UNITED STATES  
DEPARTMENT OF THE INTERIOR  
BUREAU OF LAND MANAGEMENT

SUNDRY NOTICES AND REPORTS ON WELLS

2. NAME OF OPERATOR  
**CHEVRON USA, INC.**

9. WELL NO.  
**1-29**

CHEVRON U.S.A., INC.  
SAND MOUNTAIN PROSPECT  
CHEVRON FEDERAL # 1 - 29

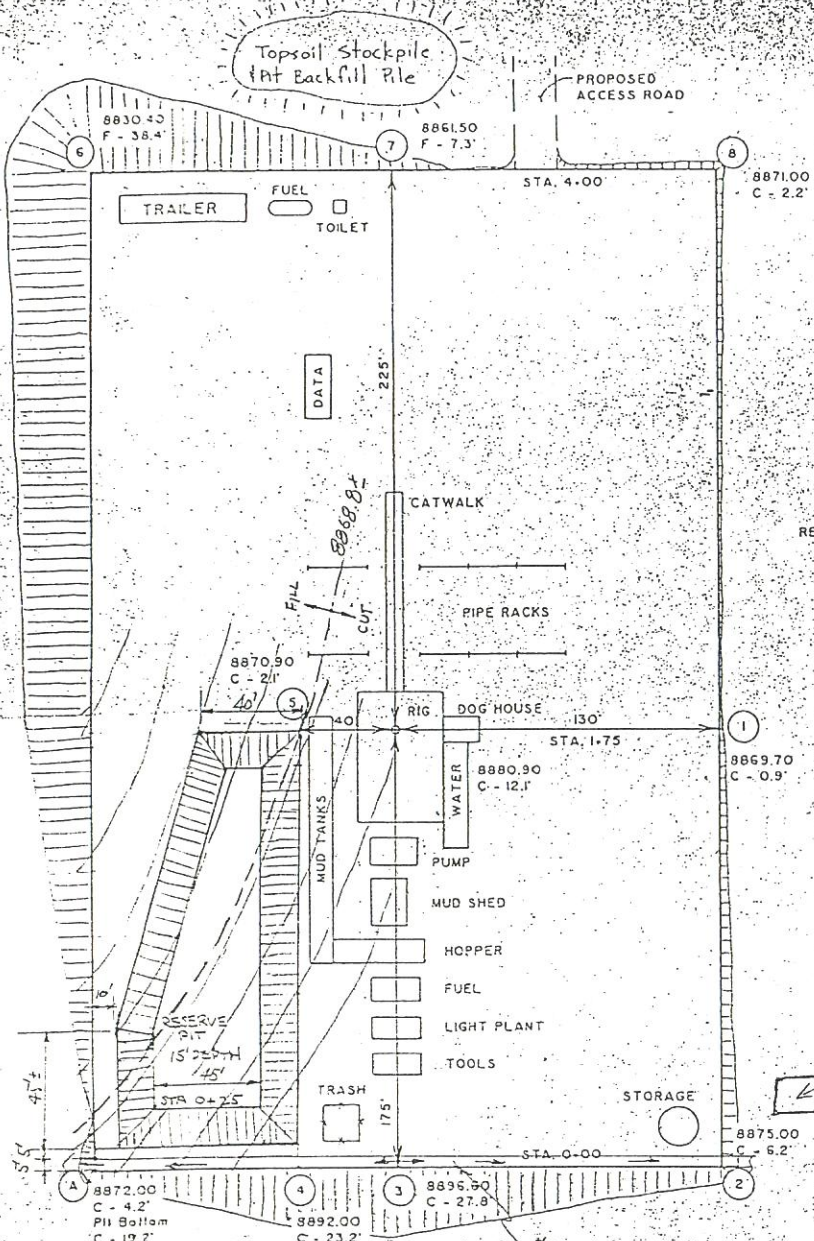
17. DESCRIBE PROPOSED OR COMPLETED OPERATIONS (Clearly state all pertinent details, and give pertinent dates, including estimated date of starting any proposed work. If well is directionally drilled, give subsurface locations and measured and true vertical depths for all markers and zones pertinent to this work.)  
**CHEVRON U.S.A., INC. PROPOSES TO UTILIZE A SEMI-CLOSED MUD SYSTEM\* DURING THE DRILLING OF THE SUBJECT WELL. PIT VOLUME WILL BE REDUCED FROM THAT PROPOSED ORIGINALLY AS SHOWN ON THE ATTACHED. AT THE TIME OF PIT RECLAMATION, FLUIDS WILL BE REMOVED TO AN APPROVED DISPOSAL FACILITY (WYMAN'S WASTE SYSTEMS), AND THE PIT WILL BE BACKFILLED & RECONTURED. THE RESERVE PIT WILL BE LINED WITH CLAY.**

\* DRILLING FLUIDS ARE CONTAINED IN TANKS. CUTTINGS, SEPARATED FROM THE RECYCLED DRILLING FLUID, ARE CONTAINED IN THE RESERVE PIT.

NOTE: THE FLARE PIT LOCATION IS SHOWN ON THE ATTACHED. FLOWLINES TO THE FLARE PIT ARE TO BE BURIED.
